Access Compliance Report

Public Rights-of-Way

(Pedestrian Signals)

Intersection ID: N/A	Main Street:	Cross Street: N/A	Location: N/A
ADA ID: FB71692202B2	Signal Type: One Push Button-APS	Overall Compliance: No	Severity Score: BTN 1: N/A BTN 2: N/A No BTN: N/A
Codes/Mitigation Info/Possible Solution		Field Measurements/Component Compliance

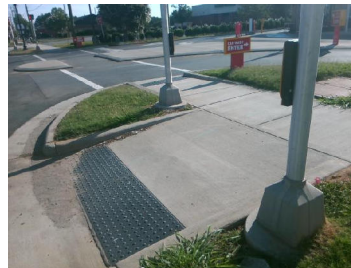
Surveyor Notes: TEXT HT 5/16

PROW/ADA: TMUTCD 4e.08, R410.6, R404.2,
R404.3, R406.2, R404.7.3, R209.1, MUTCD
4e.10

Possible Solutions: Remove & Replace
Replace APS Button With New APS Button.
Remove & Replace Crossing Striping.
Remove and Replace Clear Space.
